## MEMORANDUM

**RE:** Proposed Cumberland Farms  
New Bedford, MA  
Response to Comments

North Driveway Sight Distance  
Cumberland Farms  
New Bedford, Massachusetts

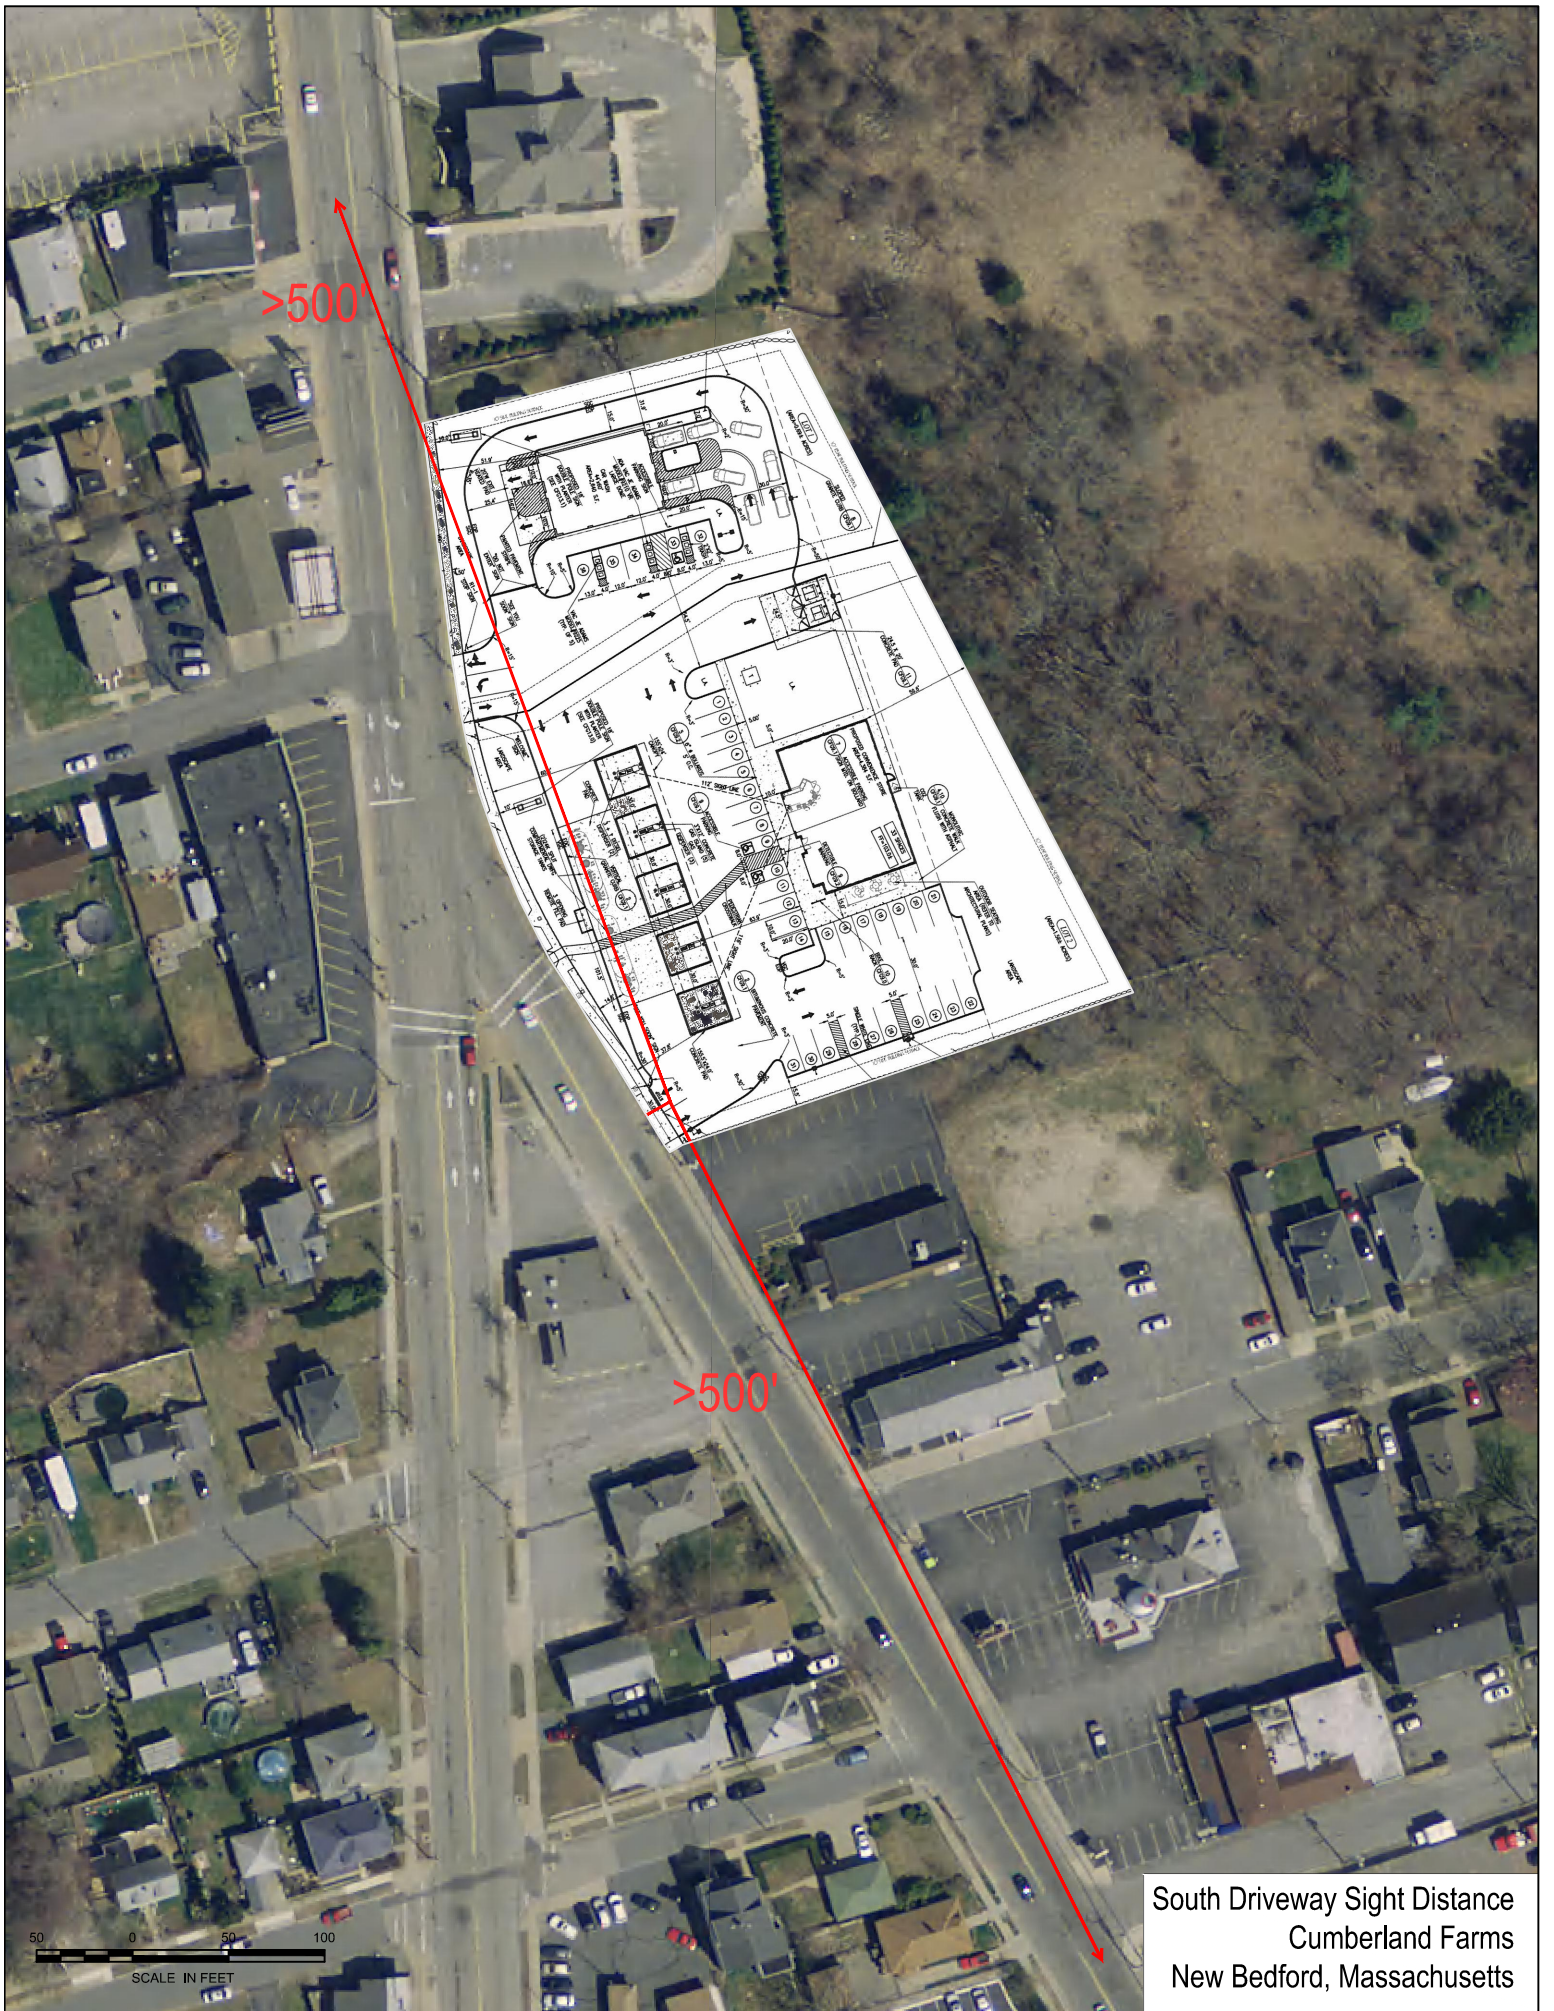
**7. Comment:** Illustrate the intersection sight distance on the site plan

**Response:** *Graphics showing the intersection sight distance on the site plan have been included as an attachment to this memorandum.*
